Access Compliance Report

Public Rights-of-Way

Intersection ID: 52289	Main Street: TROJAN_DR	Cross Street: DIXIE_RIVER_RD	Location: NW
ADA ID: 628E192B4057	Ramp Type: Perp	Initial Pass/Fail: Fail	Overall Compliance: No
		Severity Score: 25

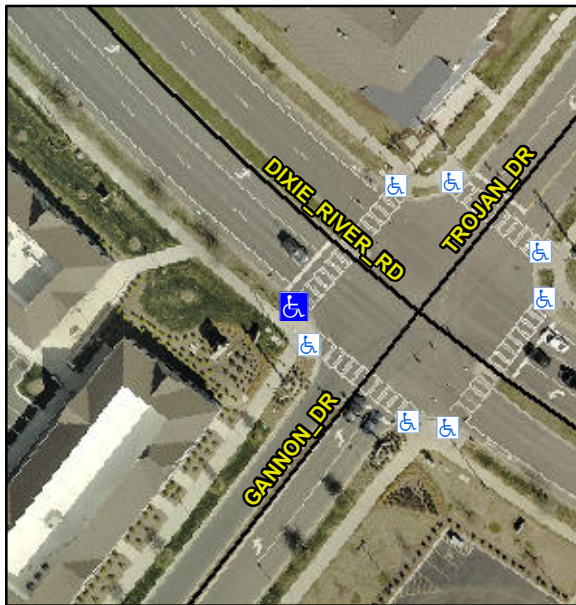
Not Found, R304.5.3

Compliance	Description	Data	Compliance	Description	Data
N/A	Ramp Length (in)	98.0	Yes	Ramp Slope (%)	6.9
Yes	Ramp Width (in)	48.0	No	Ramp XSlope (%)	9.6
N/A	Flare Type LT	N/A	N/A	Flare Type RT	N/A
N/A	Flare Slope LT (%)	N/A	N/A	Flare Slope RT (%)	N/A
N/A	Flare Traversable LT?	N/A	N/A	Flare Traversable RT?	N/A
N/A	Landing Length (in)	N/A	N/A	DWS Provided?	N/A
N/A	Landing Width (in)	N/A	N/A	DWS Contrast?	N/A
N/A	Landing Slope (%)	N/A	N/A	DWS Length (in)	N/A
N/A	Landing X Slope (%)	N/A	N/A	DWS Full Width?	N/A
N/A	Landing Curb? (Y/N)	N/A	N/A	DWS Offset (in)	N/A
N/A	Shared Landing?	N/A			
N/A	Gutter Ponding?	N/A	N/A	Gutter Slope (%)	N/A
N/A	Gutter Lip Ht (in)	N/A	N/A	Gutter X Slope (%)	N/A
N/A	Painted X Walk1?	Yes	N/A	Painted X Walk2?	N/A
	X Walk 1 Direction	To NE		X Walk 2 Direction	N/A
N/A	X Walk 1 Width (in)	112.0	N/A	X Walk 2 Width (in)	N/A
	X Walk 1 Slope (%)	0.9		X Walk 2 Slope (%)	N/A
	X Walk 1 X Slope (%)	3.8		X Walk 2 X Slope (%)	N/A

Remove & Replace Entire Ramp.
